SR 360 WIDENING
CSSTP-0006-00(049) - P.I. No. 0006049
Cobb and Paulding Counties, Georgia

Value Engineering Study Report
Preliminary Design Stage

re: Project No. CSSTP-0006-00(049), P.I. #0006049
Widening of SR 120/Charles Hardy Parkway to SR 176/Lost Mountain Road
Value Engineering Study Report

ALT. NO.
ROW-7
Sht 2 of 4

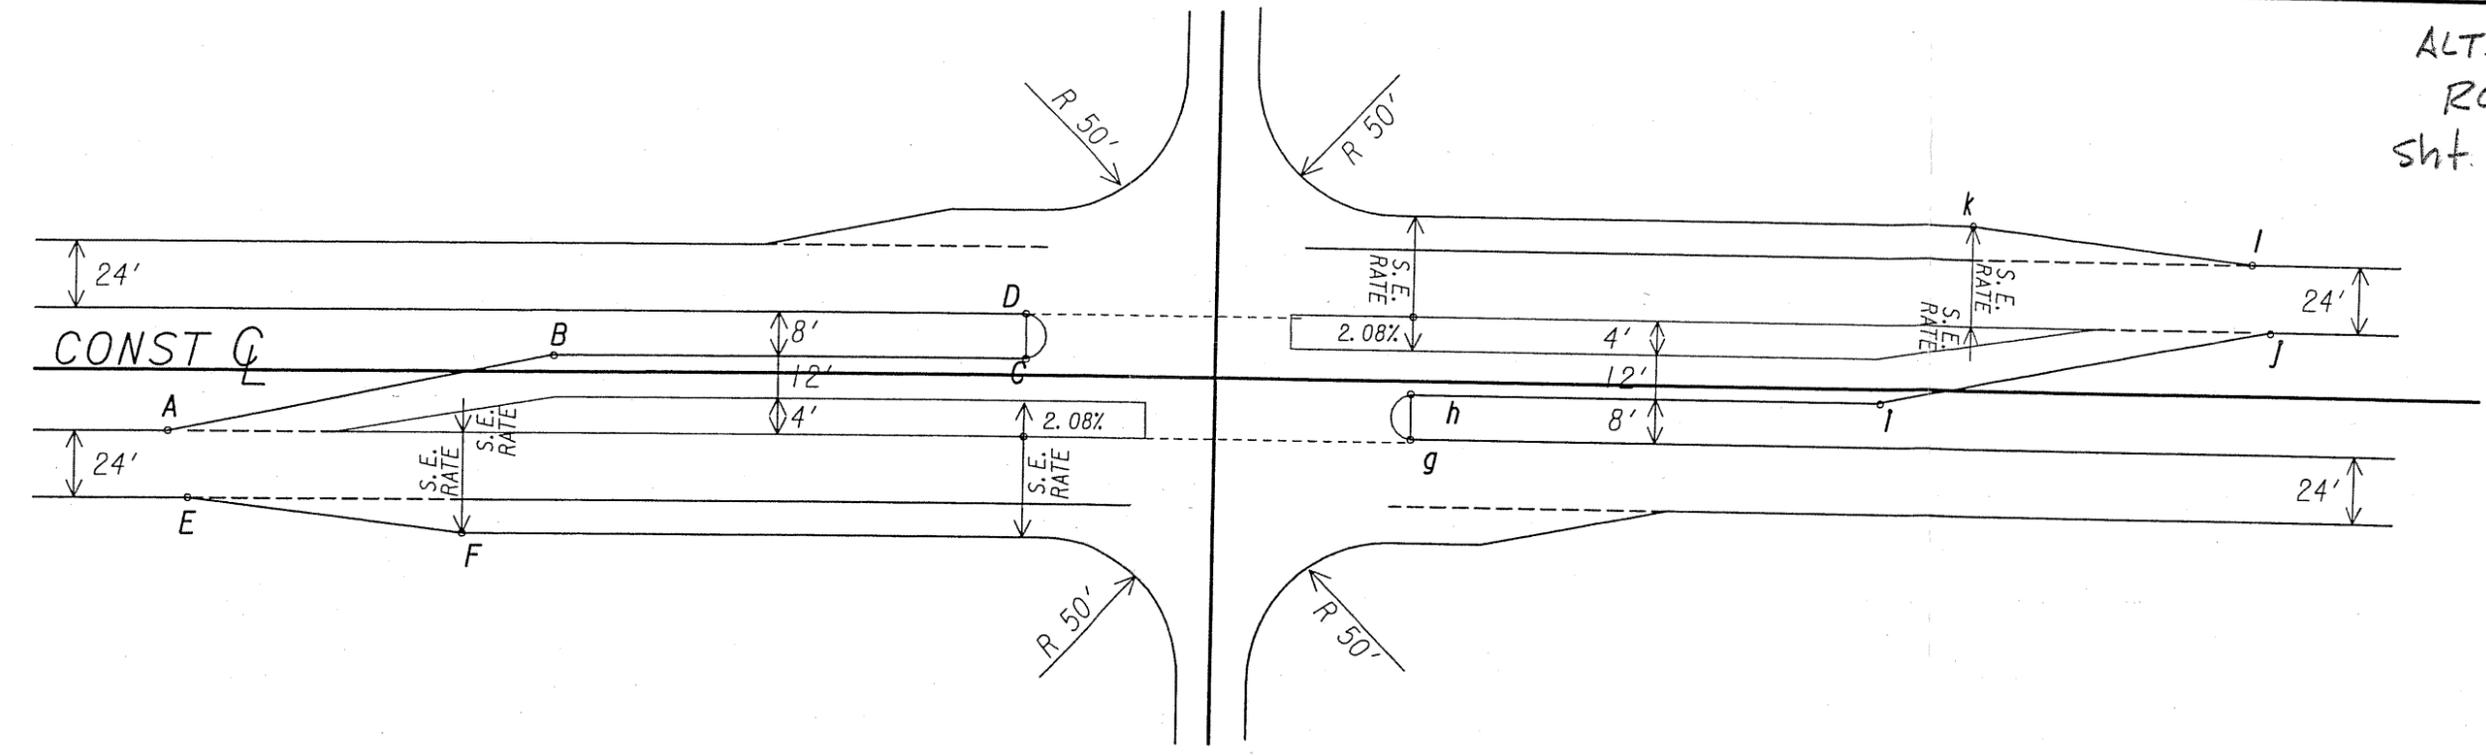
DESCRIPTION: **ELIMINATE THE 4-FT.-WIDE BUFFER STRIPS AT THE LEFT-TURN LANE POCKETS IN THE MEDIAN** SHEET NO.: **1 of 4**

Delete the 4-ft.-wide painted pavement area.

DRAWING No.
5-01

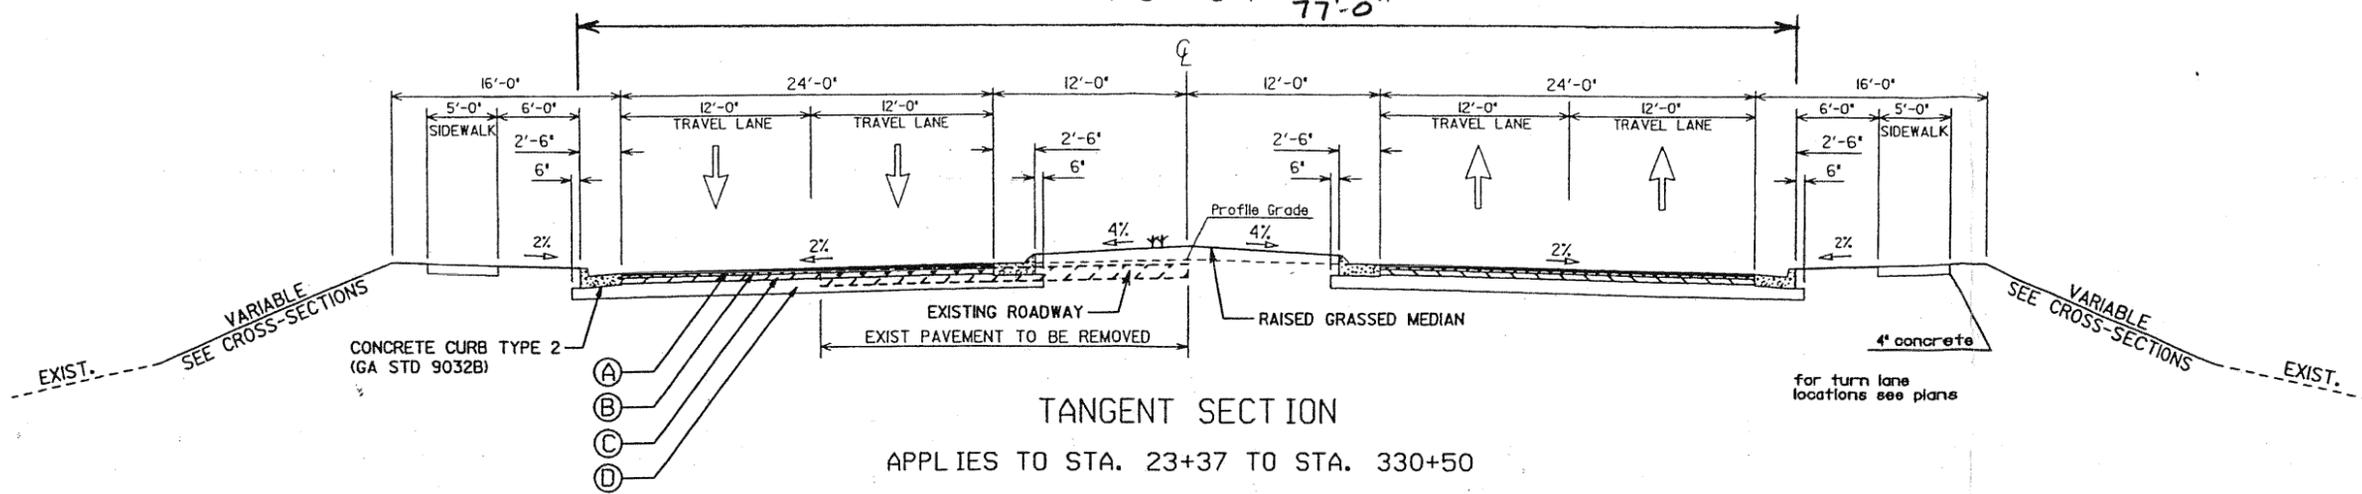
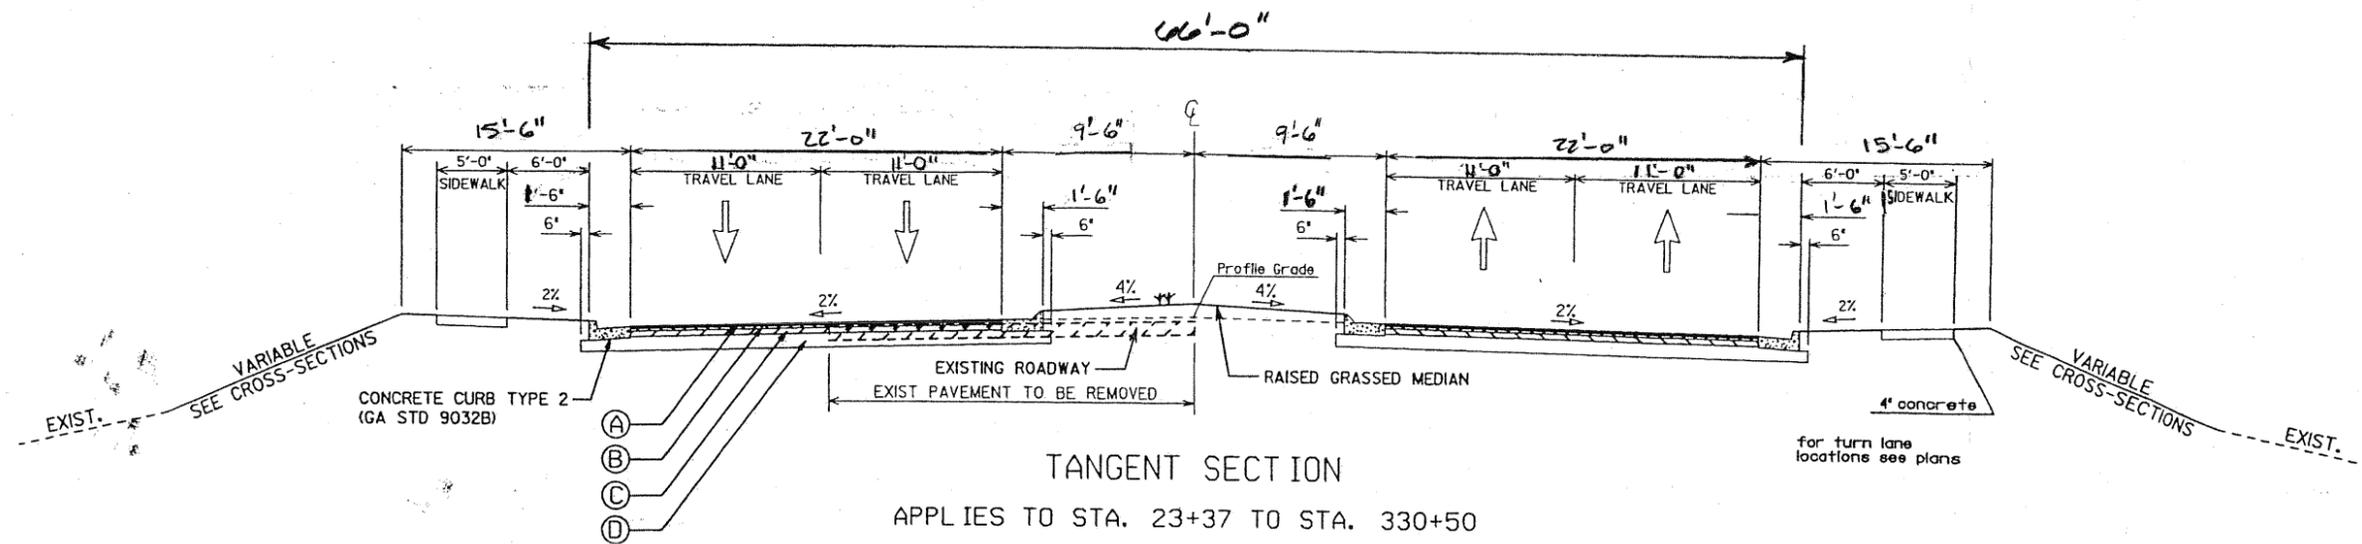
DESCRIPTION: **REDUCE THE BACK OF OUTSIDE CURB TO BACK OF OUTSIDE CURB DISTANCE TO THE MINIMUM (COMBINE ALT. NOS. P-1, ROW-1 AND ROW-7)** SHEET NO.: **1 of 5**

In the typical section, the face of outside curb to face of outside curb dimension is 76 ft., which includes four 30-in.-wide curbs, four 12-ft.-wide paved travel lanes, two 6-in.-wide curbs at the median, and a 19-ft.-wide landscaped median. Where a left-turn lane is placed in the median, a 4-ft.-wide buffer zone is between the through lane and the turn lane is also added resulting in an 8-ft.-wide nose piece consisting of two 30-in.-wide curb and gutter sections and 3-ft.-wide concrete infill piece. Where right-turn lanes are needed, add a 12-ft.-wide lane to the outside of the through lanes.

Reduce the back of outside curb to back of outside curb dimension to the minimum by using 18-in.-wide curb and gutter sections at the outside edge of the roadway and at the median, 11-ft.-wide paved travel lanes, and 16-ft.-wide landscaped median for a total width of 66 ft. At the nose sections where left-turn lanes are added to the median, use an 11-ft.-wide lane, delete the 4-ft.-wide buffer zone, leaving an 8-ft.-wide median consisting of two 18-in.-wide curb and gutter sections and a 5-ft.-wide concrete infill piece. Use an 11-ft.-wide lane for the four dedicated right-turn lanes. Move centerline alignment so the total savings in right-of-way occurs on one side of the road in order to avoid taking some residential and commercial properties.

AS DESIGNED ALTERNATIVE

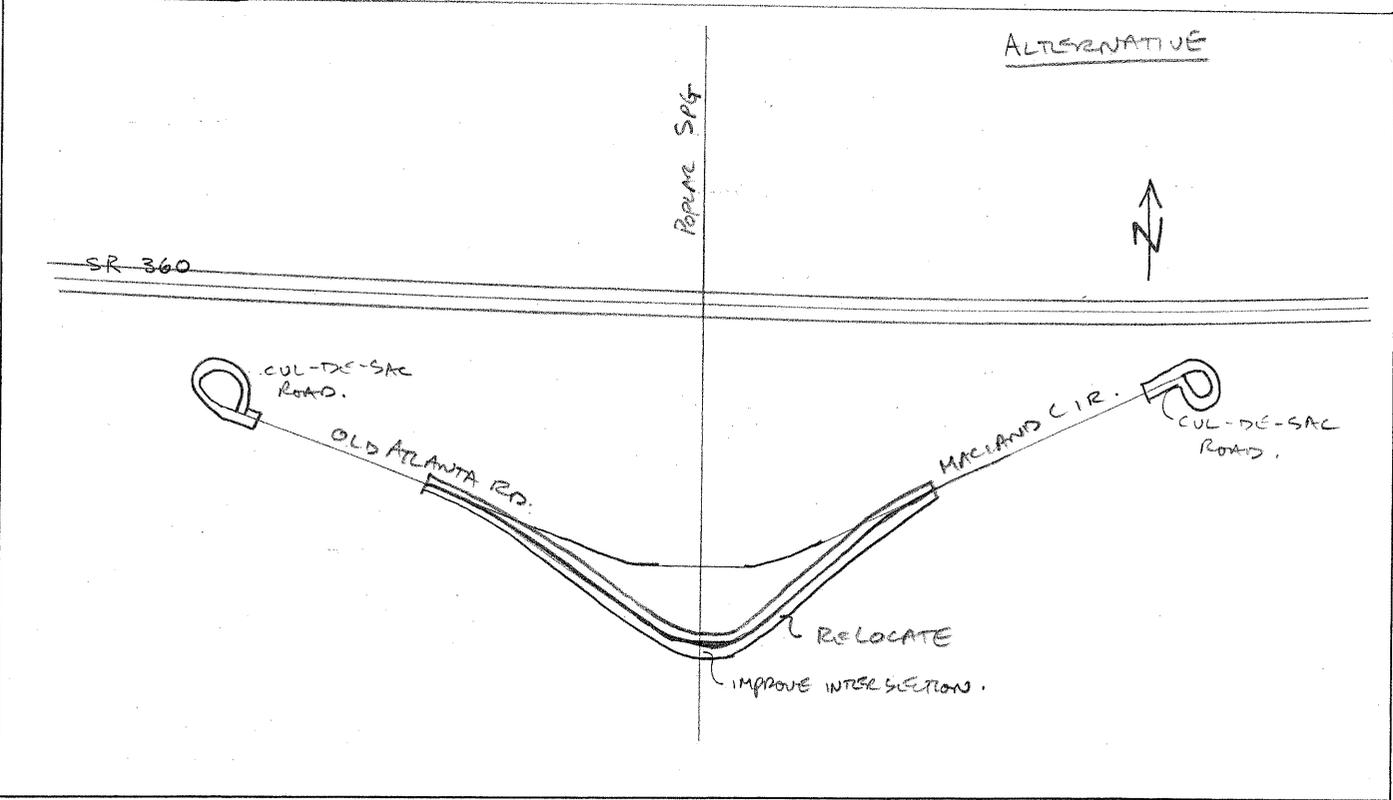
DESCRIPTION: IMPROVE INTERSECTION AT POPLAR SPRING ROAD WITH OLD ATLANTA ROAD/MACLAND CIRCLE AND REMOVE INTERSECTIONS OF ATLANTA ROAD AND MACLAND CIRCLE WITH SR 360

Add and improve two intersections at Macland Circle and Old Atlanta Road with SR 360.

There are too many intersections too close together along SR 360. This alternative eliminates two of them and channelizes the traffic to Poplar Spring Road before routing it to SR 360. Although this change saves costs, it can be justified based on safety improvements alone.

Remove proposed intersections and cul-de-sac Macland Circle and Old Atlanta Road. Improve the intersection of Poplar Spring Road with Macland Circle/Old Atlanta Road by relocating it south if needed to miss left-turn pockets from proposed Poplar Spring Road/SR 360 intersection improvements.
